UNITED STATES PATENT AND TRADEMARK OFFICE

APPLICATION NO.	FILING DATE	FIRST NAMED INVENTOR	ATTORNEY DOCKET NO.	CONFIRMATION NO.
10/693,195	10/24/2003	Randall R. Geib	0241-P03282US0	2326

Office Action Summary

DETAILED ACTION

FIG. 2

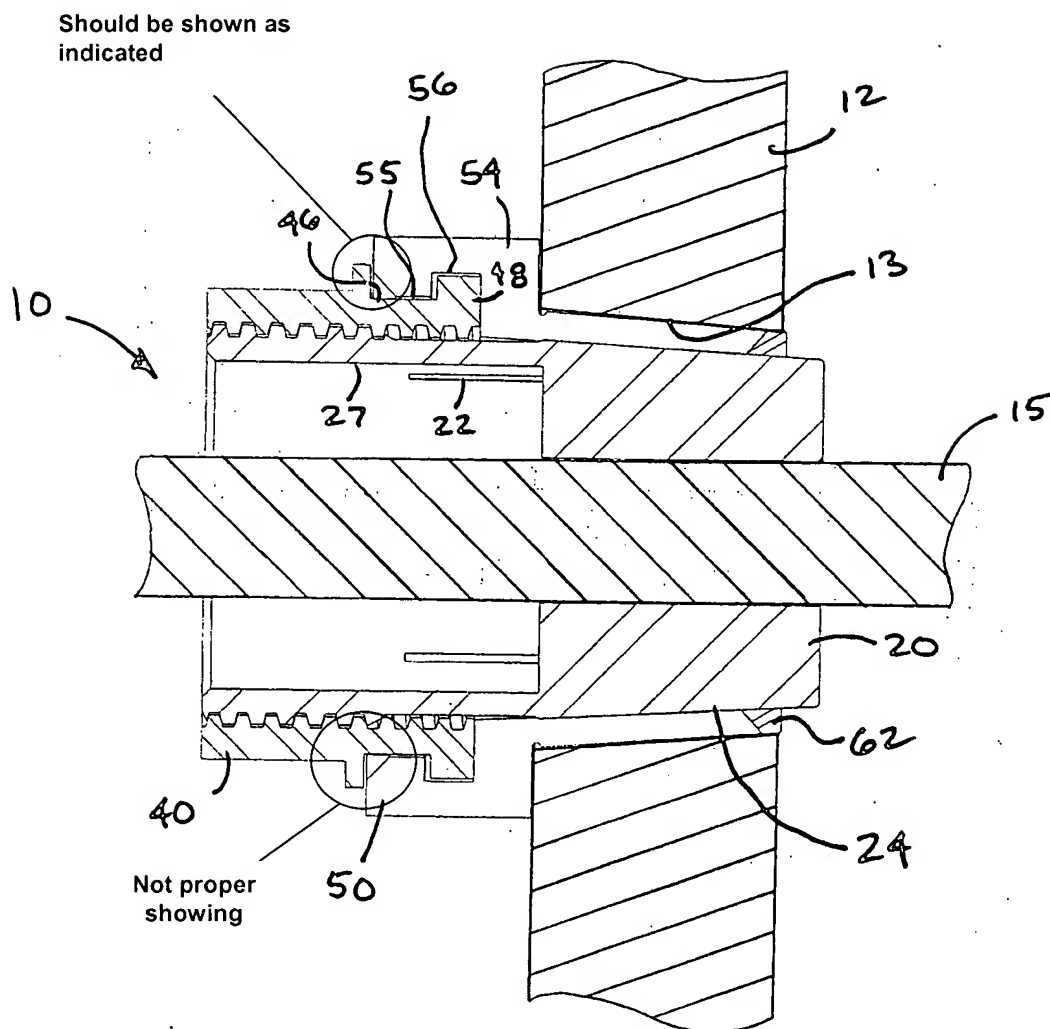
The drawings are objected to because the cross section view of the chamfered surface (unreferenced) of the flange 55 is not shown accurately. See attachment of marked-up Figure 2 to find the cross section view as correctly fixed by the examiner.
